<b>ADDENDUM NO. :</b>	<b>Four (4)</b>
<b>BID DUE TIME AND DATE:</b>	2:00 p.m., April 30, 2019 <b>(No Change)</b>
<b>BIDDER QUESTIONS BY:</b>	11:59 a.m., April 23, 2019
<b>LAST ADDENDUM ISSUED:</b>	11:59 p.m., April 25, 2019

**THE PURPOSE FOR THIS ADDENDUM IS:**

- **To provide a response to questions raised by Plan Holders;**
- **To modify/clarify specifications and drawings.**

**C4 DETAIL DOCK CANOPY**  
SCALE: 1 1/2" = 1'-0"

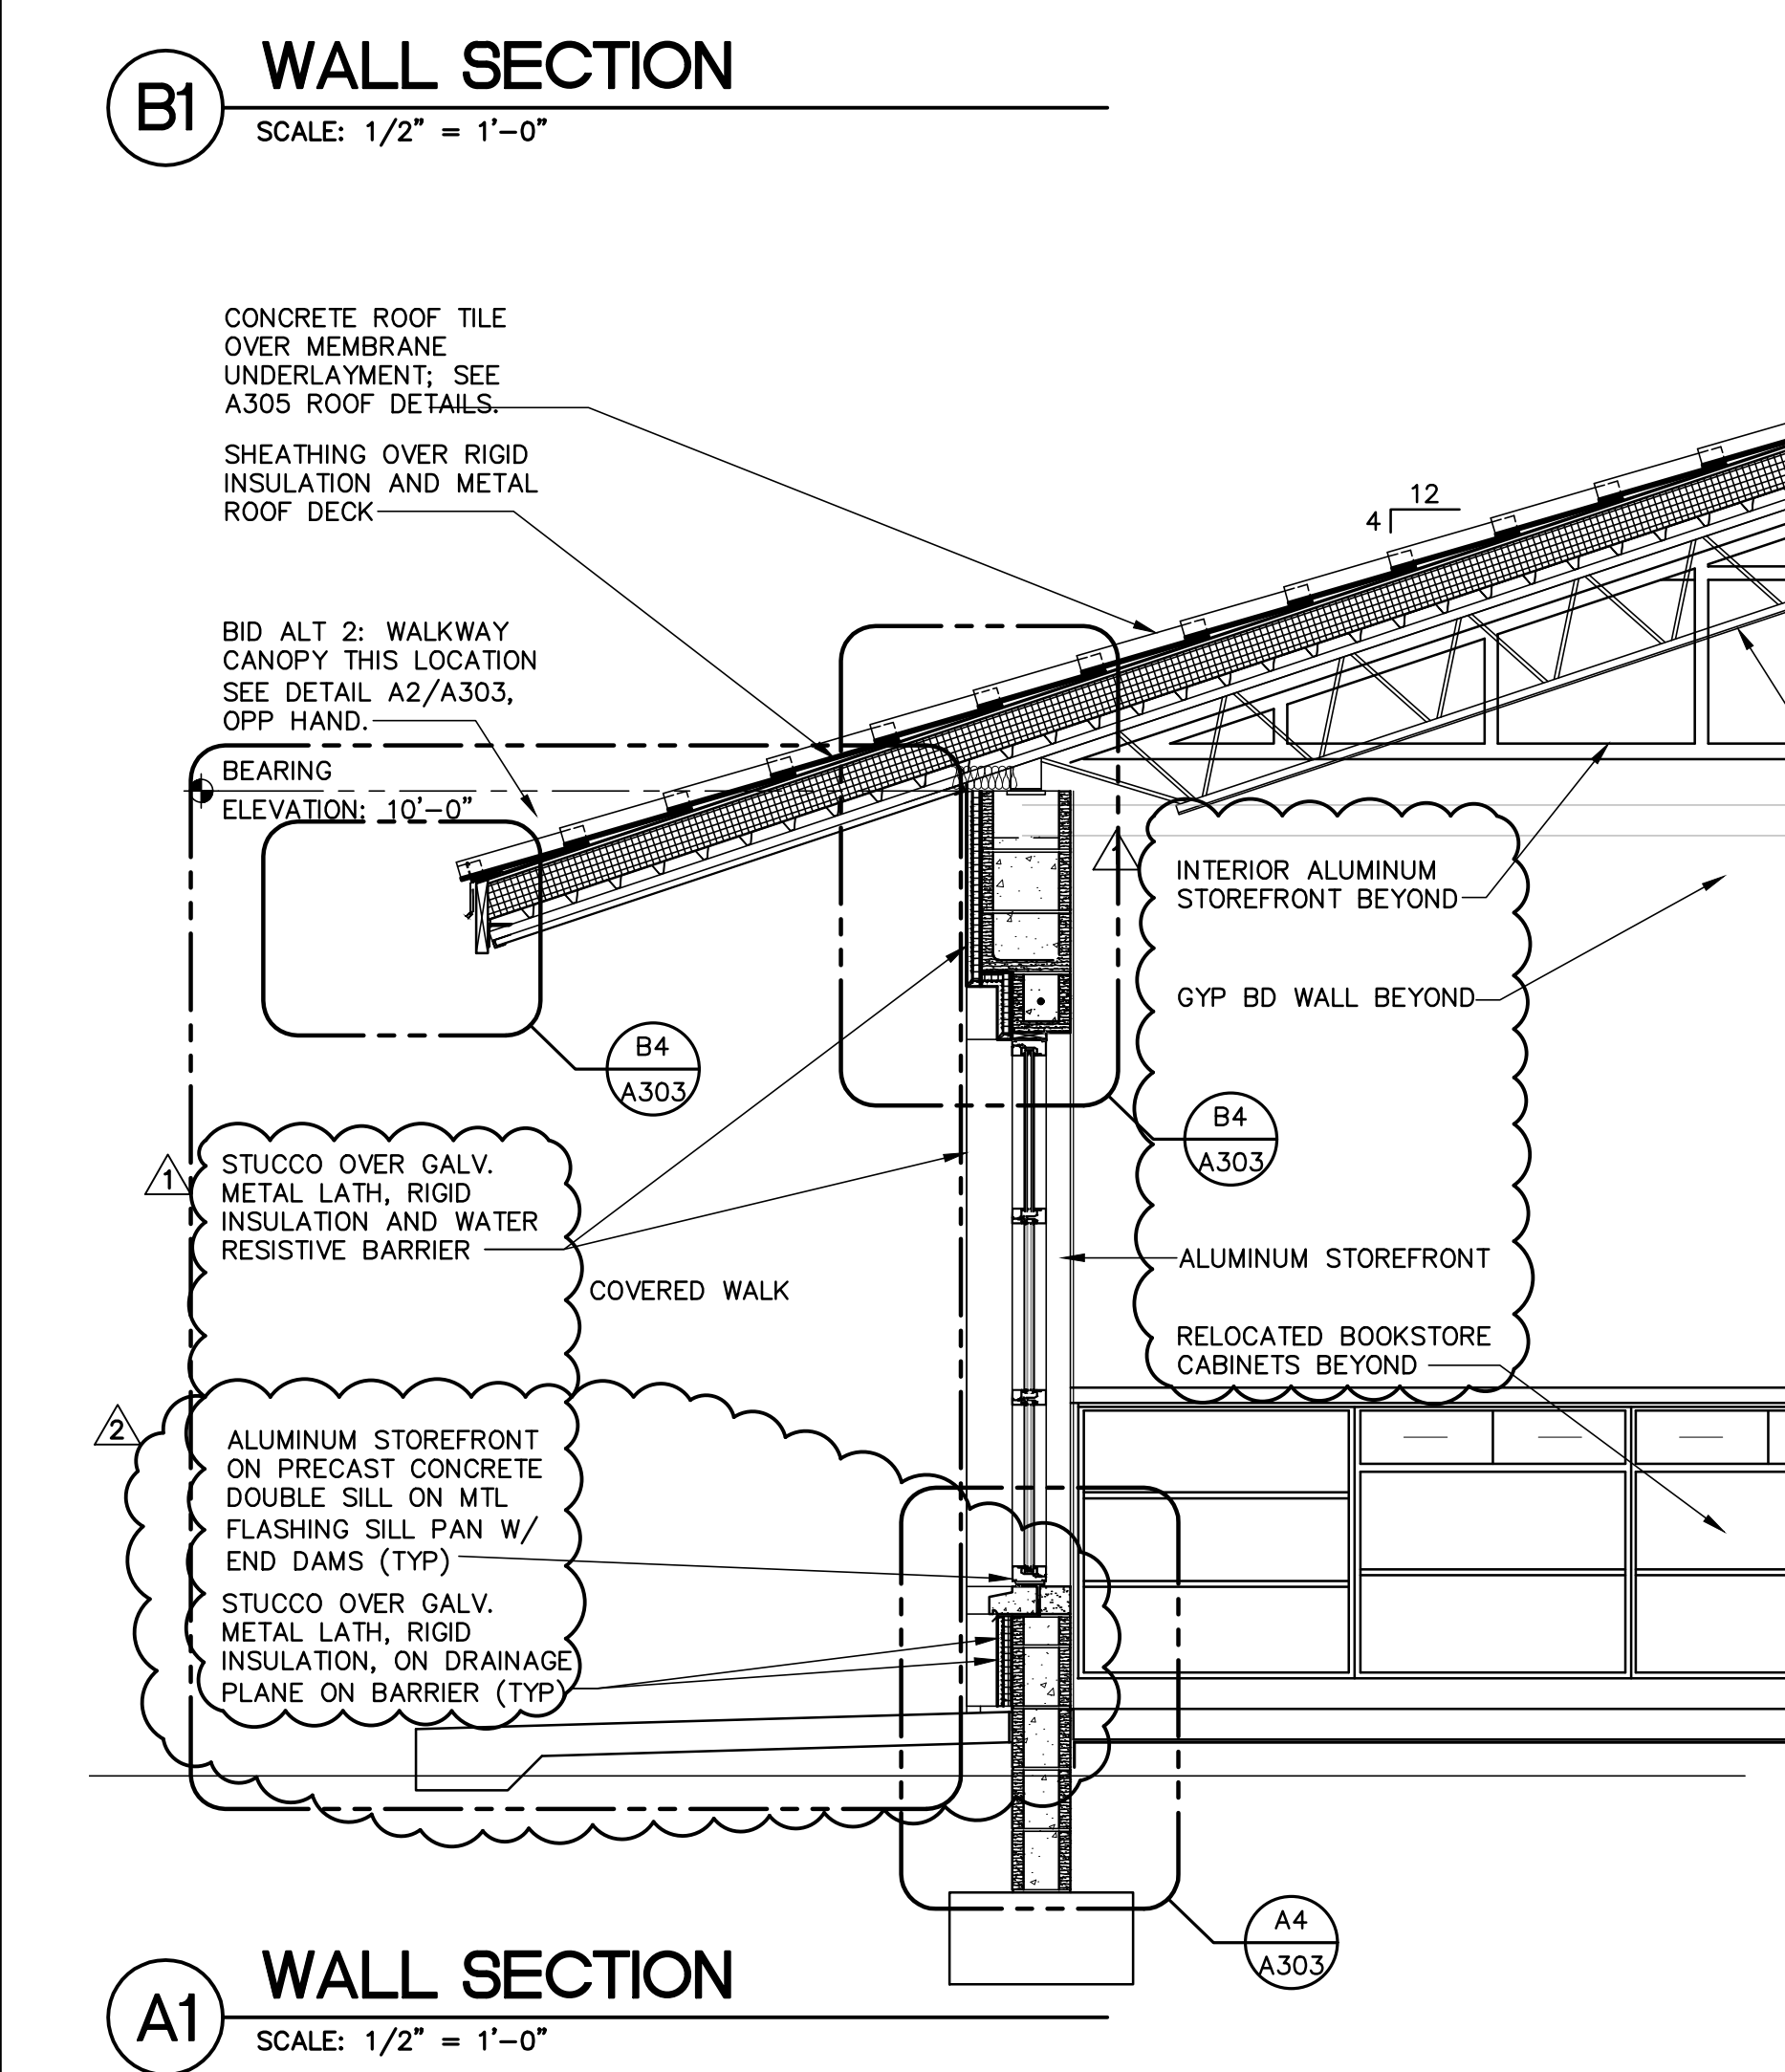
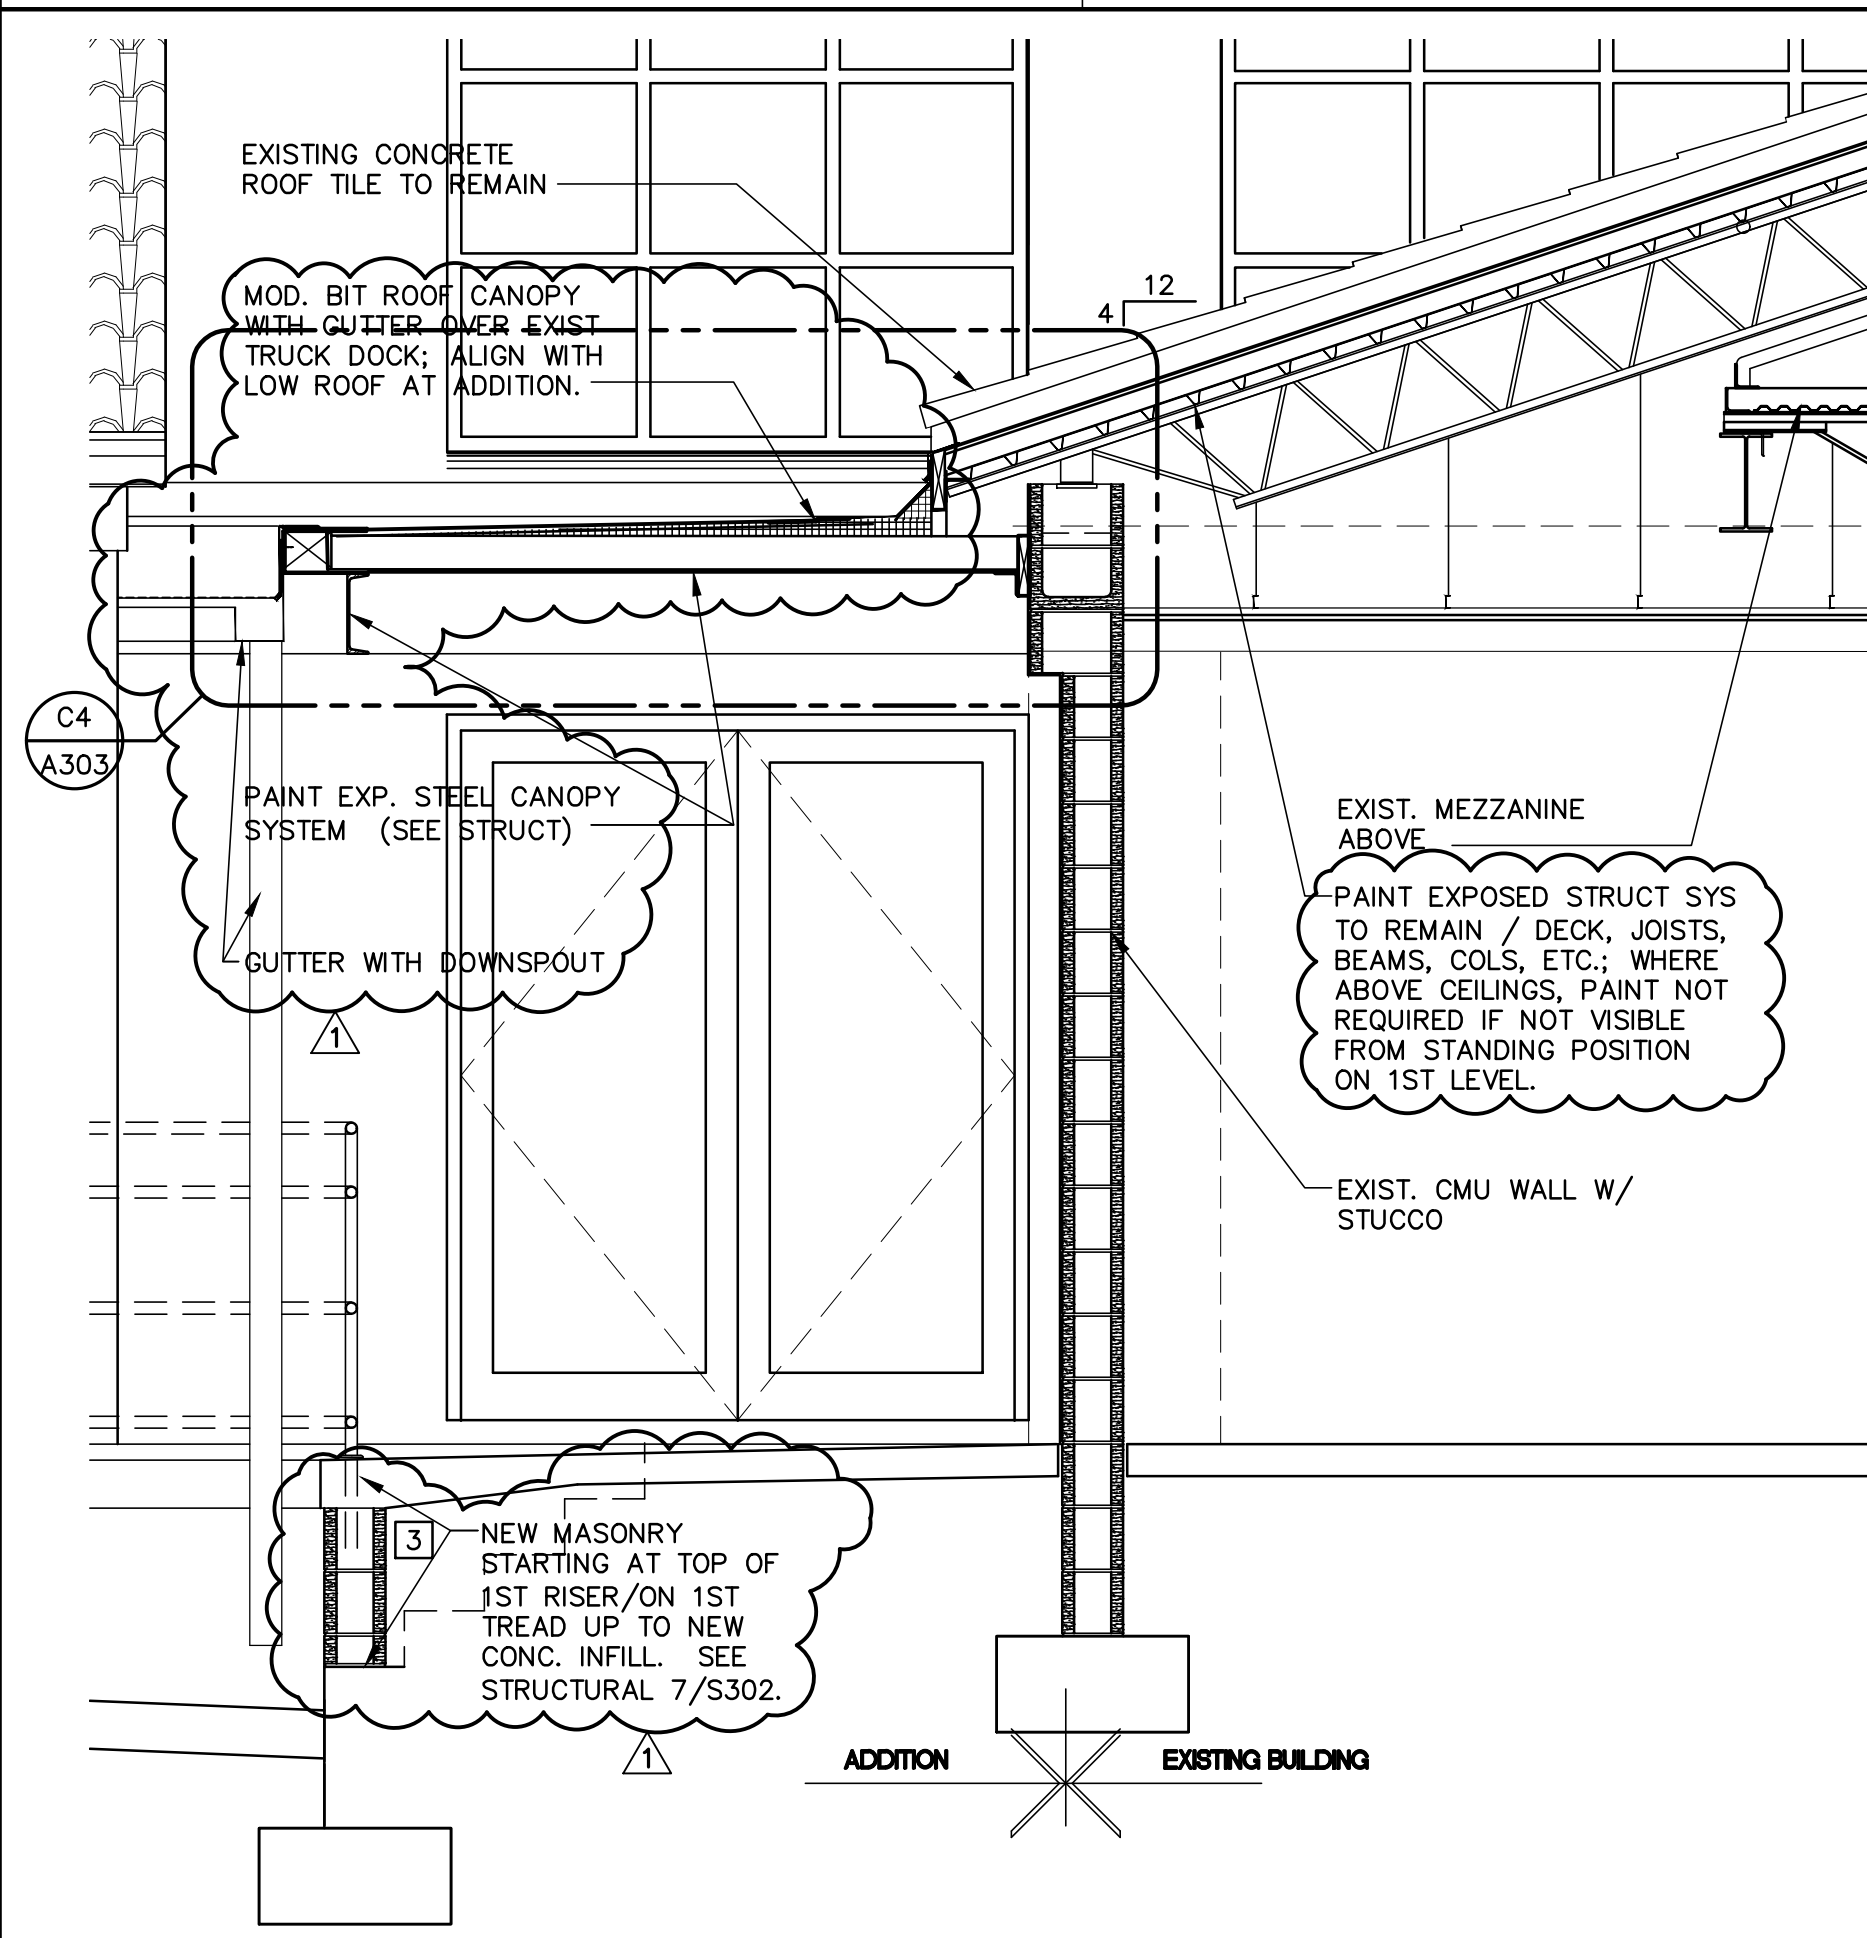
- Clarification on the wall types (section on acoustical separation, 2 hr, and detail at top of 10' wall) and ceiling cloud detail(s) and finish details such intent of columns for exposed electrical on CMU
- HVAC details such as air handler coil connection (what's needed re isolation valves, strainers, etc.)
- Extent of chilled water line treatment
- Specs/detail on OA louver to be installed within storefront (shown on HVAC, visible on Section A301, not A202 or A602)
- Redundancy on, and revisions to a few Hardware items; see hardware Spec sections attached.
- Sections clarified to indicate sill pan, as well as location of drainage barrier; all sections at stucco clarified to show weep at base of drainage plane. Additionally, simplify cast sills.

- A301 Building Sections
- A302 Building Sections
- A303 Ext Wall Sections & Details
- A304 Ext Wall Sections & Details
- A306 Ext Wall Sections & Details
- A502 Ceiling Details
- A601 Finish Schedule w/ Details
- P101, Updated plan to show missing fixtures and missing sanitary and vent piping
- P102, Updated plan to show missing fixtures, missing domestic water piping and missing gas piping
- P101, Updated plan to show missing fixtures and missing sanitary and vent piping
- P201, Updated plan to show missing fixtures and missing sanitary and vent piping
- P202, Updated plan to show missing fixtures, domestic water piping and missing gas piping
- M401, Added detail for chilled water connections to AHU
